**CEQA Addendum No. 3**

**Initial Study/Mitigated Negative Declaration**

**Conveyance of Refuge Water Supply Project**

**East Sacramento Valley Study Area**

Figure 2. Site Plan.

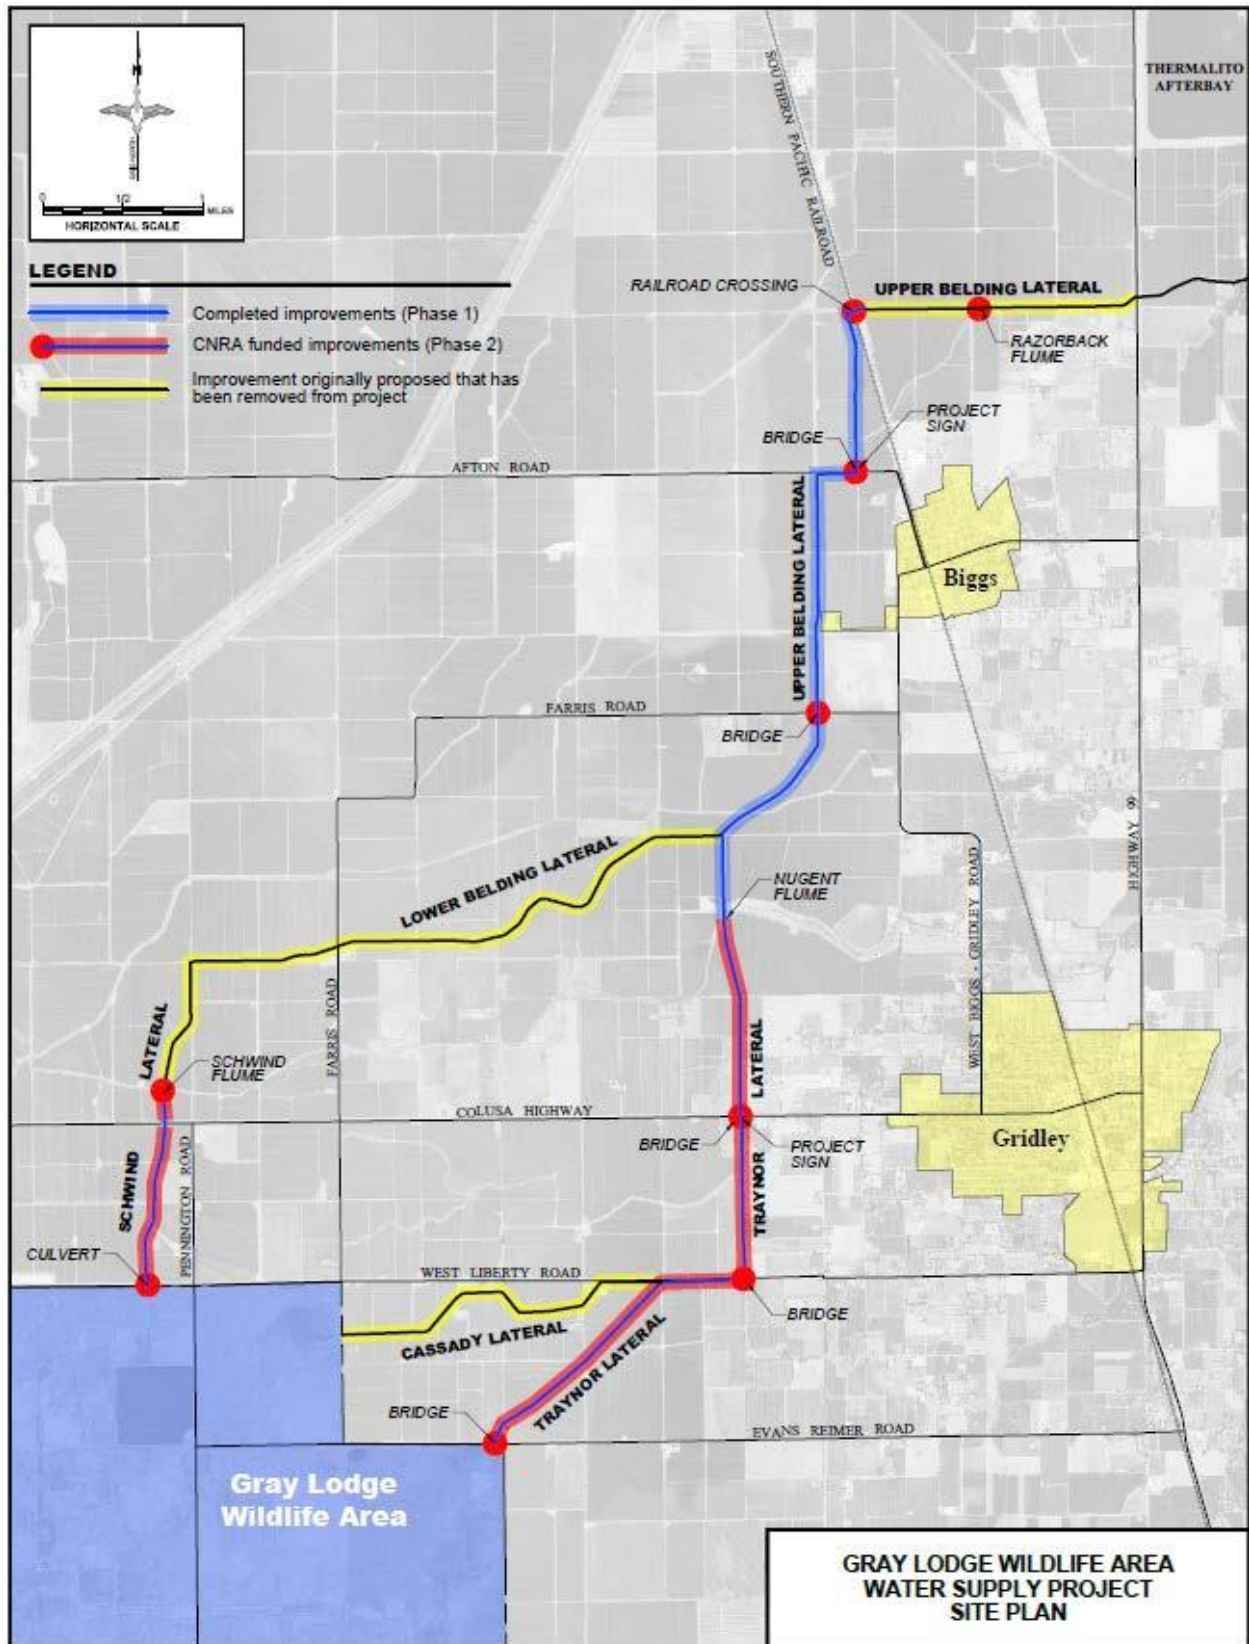
The Proposed Project identified as Phase 2, was updated to eliminate the reconstruction of 9.32 miles of laterals including the entire Lower Belding and Cassady, and portions of Upper Schwind and Belding Laterals (3.65, 3.12, 0.75, and 1.8 miles, respectively). In addition to this, the Proposed Project eliminated the construction of 26 structures including turnouts and lateral head gates; road bridges; and culvert, drain and farm crossings. Figure 2 and Table 1 shows the main changes to the Original Project.

- **Traynor Lateral Outlet onto GLWA.** The crested weir and the associated head gate, pipeline and concrete work of the Jakey Ditch head gate supply pipeline was removed. These plans will be replaced with a Langemann gate weir located on Gray Lodge approximately 80 feet downstream of the Evans-Reimer Road Bridge, a rock overflow weir and spillway located 50-feet south of the Evans-Reimer Road Bridge, and reconstruction of the existing Jakey Ditch head gate in place.

- **Schwind Lateral Water Delivery to GLWA at West Liberty Road.** At this location the proposed construction of a siphon under West Liberty Road was cancelled. The Proposed Project would replace the two existing, dilapidated corrugated metal pipes (CMPs) with new CMPs or steel pipes of the same size and in the same location, and adds the installation of a third 36-inch diameter CMP or steel pipe to supplement flow capacity to meet the need for delivery from the Schwind Lateral onto GLWA.

- **County Road Bridge Redesigns.** The Proposed Project would increase the length of the culverts under the County roads, from the County-required minimum 32 feet, to 50 to 64 feet, depending on their location. These changes occurred due to new safety guidelines that would require the installation of 150-foot long guardrails with the previous design. These guardrails would require additional relocation of access roads and increase the Proposed Project impacts. The new design would eliminate these impacts.

Figure 3. Staging Areas.

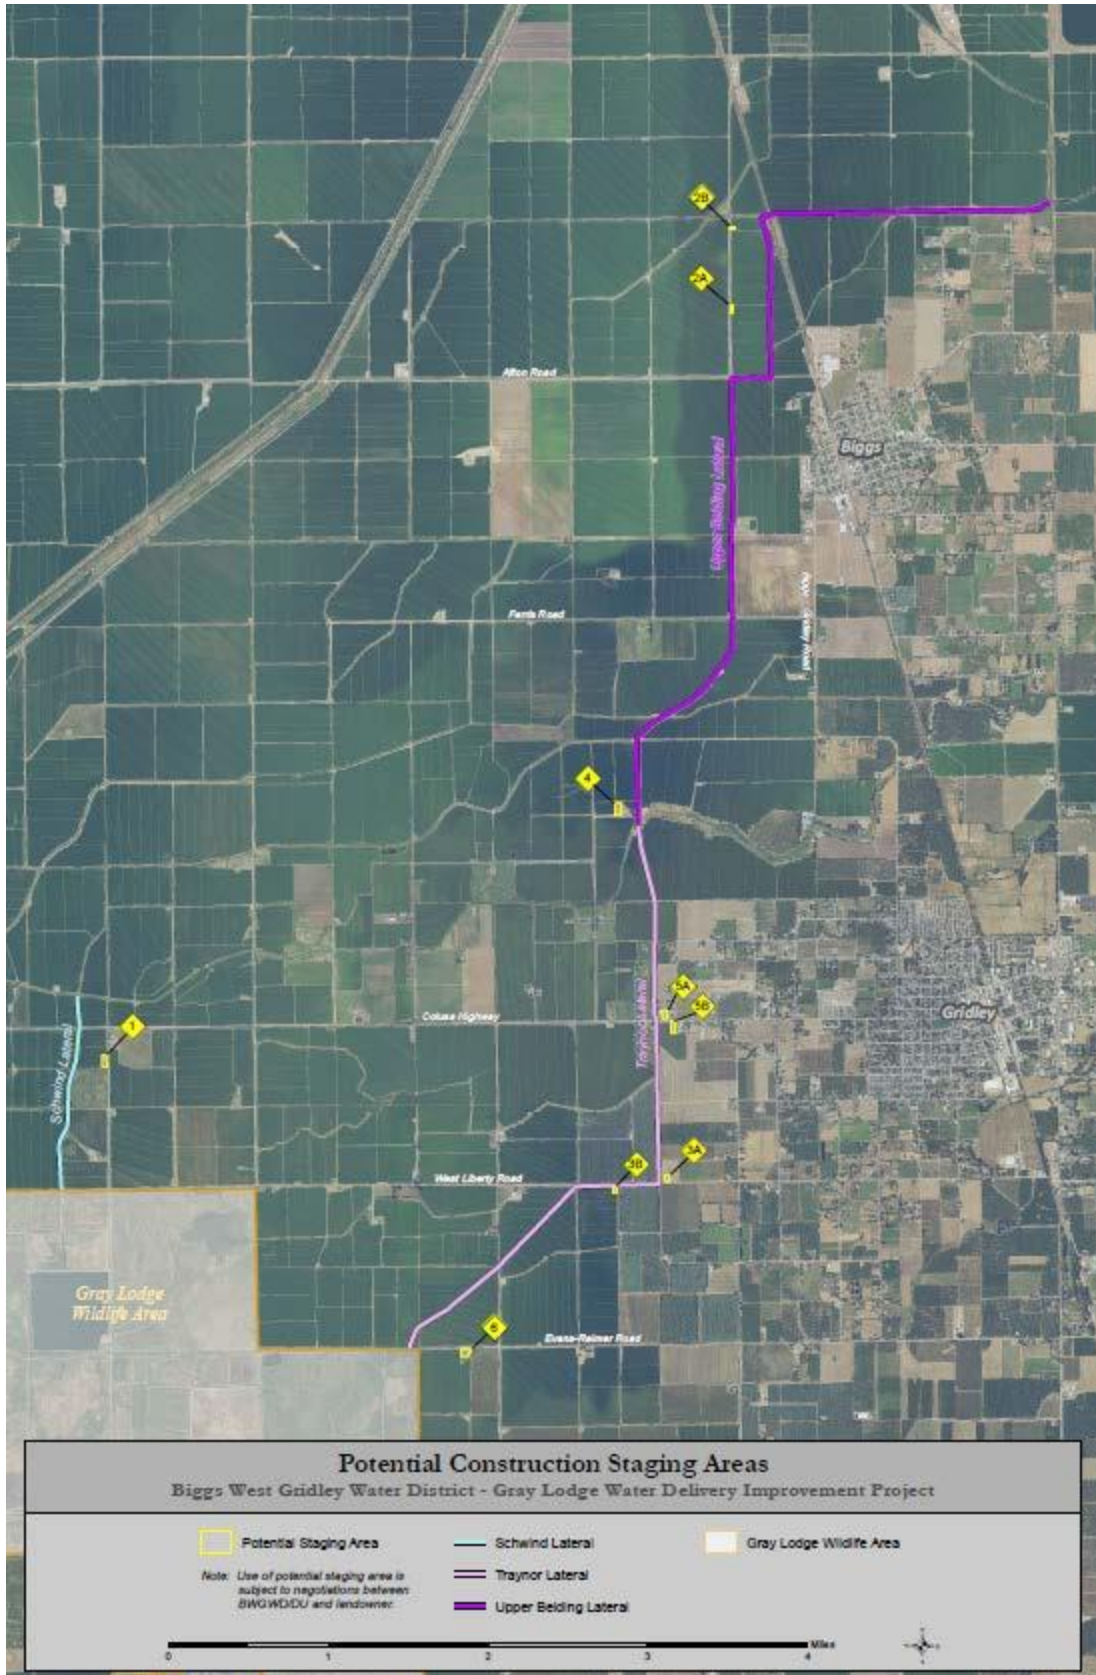
- **Additional Staging Areas.** Nine staging areas were analyzed for potential use during construction. Figure 3 shows the location of all the potential staging areas. These options were selected based on a combination of factors including necessity, proximity to construction, reasonable access from major roads, adequate size for trailers and large equipment, and minimal impact to potential wildlife habitat. Up to 6 of the 9 staging areas would be used by the Proposed Project, culminating in an affected area of no more than 5.18 acres, based on selection and use of the largest of the six staging area options. Each staging area is anticipated to be used for one or two construction seasons. Therefore, all six staging areas would not be used at the same time or for the entire period of performance for the Proposed Project.

Figure 4 By-pass Schematic

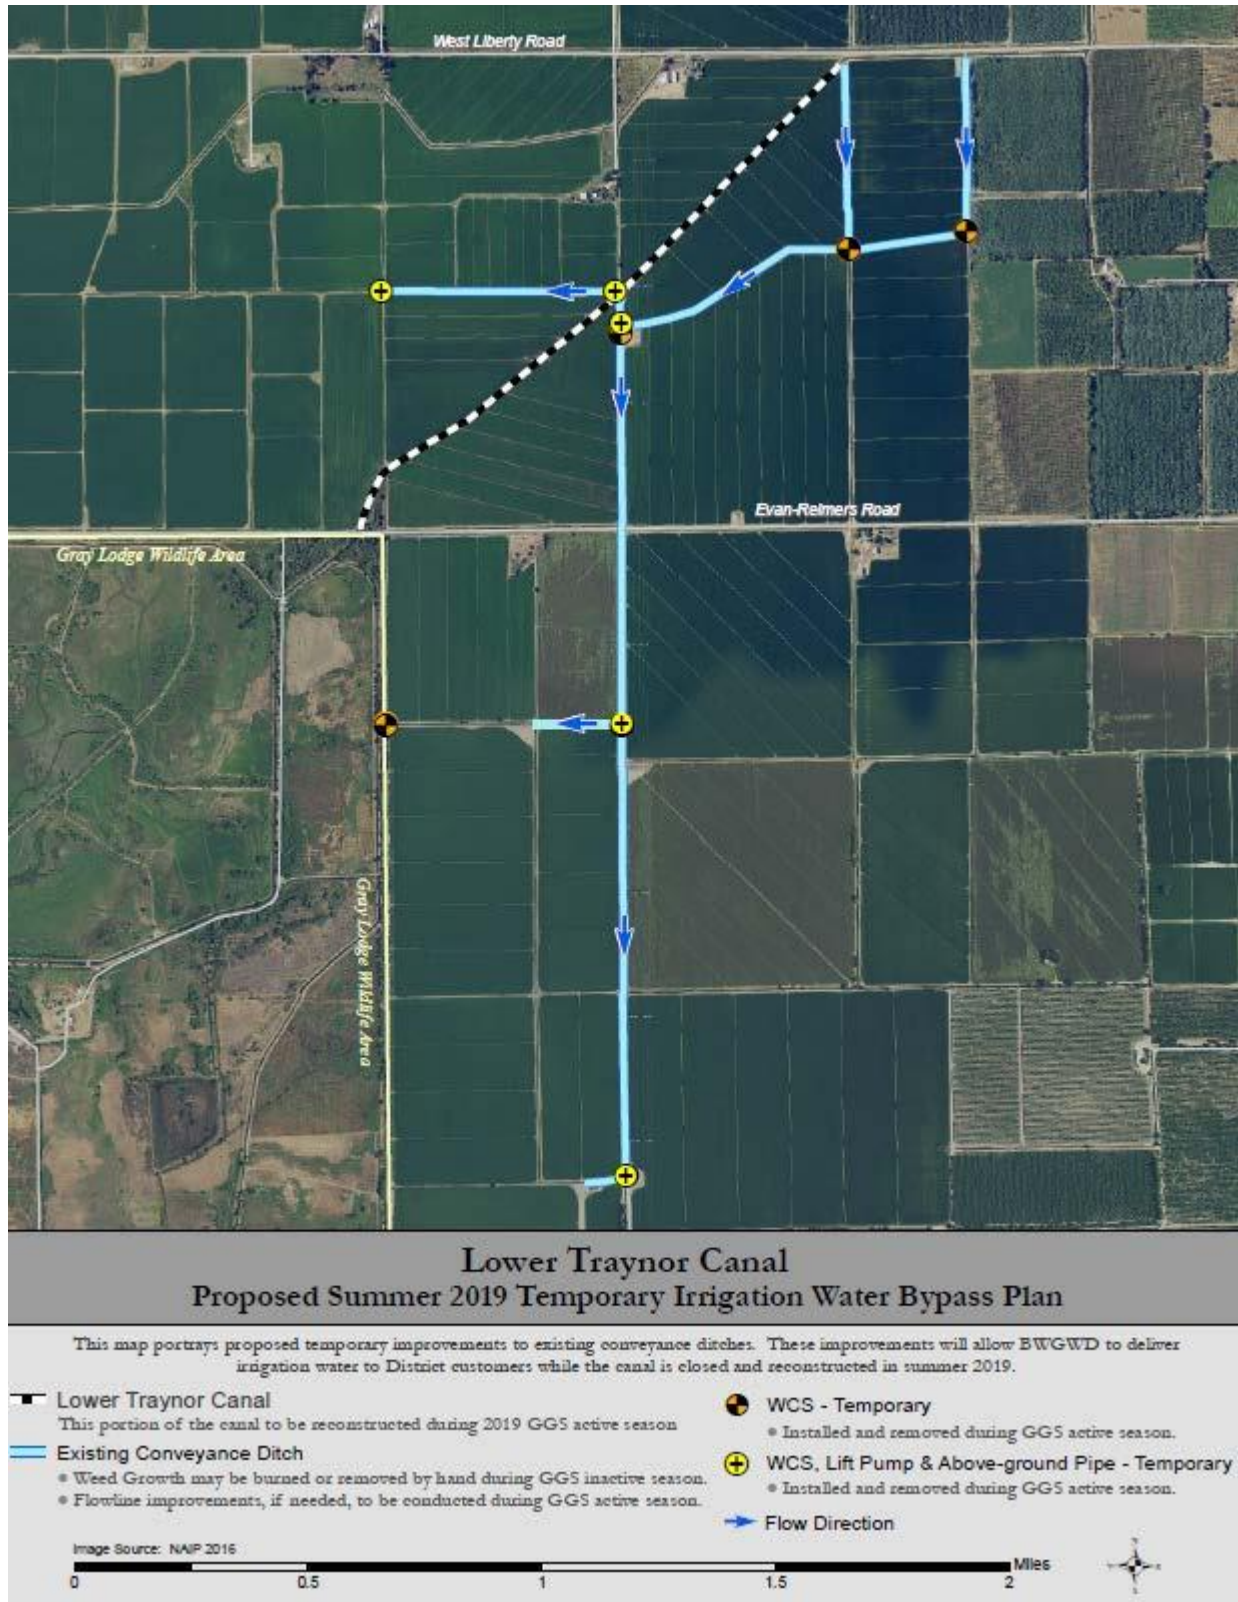
The by-pass system will use pumps and other temporary delivery features to be installed along existing conveyance and drainage ditches to convey water to areas that would otherwise be affected by the summer Lower Traynor Lateral reconstruction work. This temporary infrastructure includes pre-cast concrete water control structures (WCS) and culverts, portable lift pumps, and above-ground delivery pipes. These features would be installed in early summer, during the GGS active season; and removed in late summer following completion of the lateral reconstruction activities. Pre-construction activities necessary to facilitate installation of the temporary by-pass infrastructure may include: a limited extent of channel cleaning to improve flow lines along portions of the existing ditches, which would be completed during the GGS active season and; hand removal/weed-eating, tractor mowing, or burning of above-ground vegetation, which would be initiated in spring but may overlap the GGS inactive season

because no below ground disturbance to vegetation would occur. Such activities are regularly carried out in these ditches by BWGWD, Reclamation District (RD) 833, RD 2054 and owners of property over which the ditches flow. The by-pass system design is depicted in Figure 4.
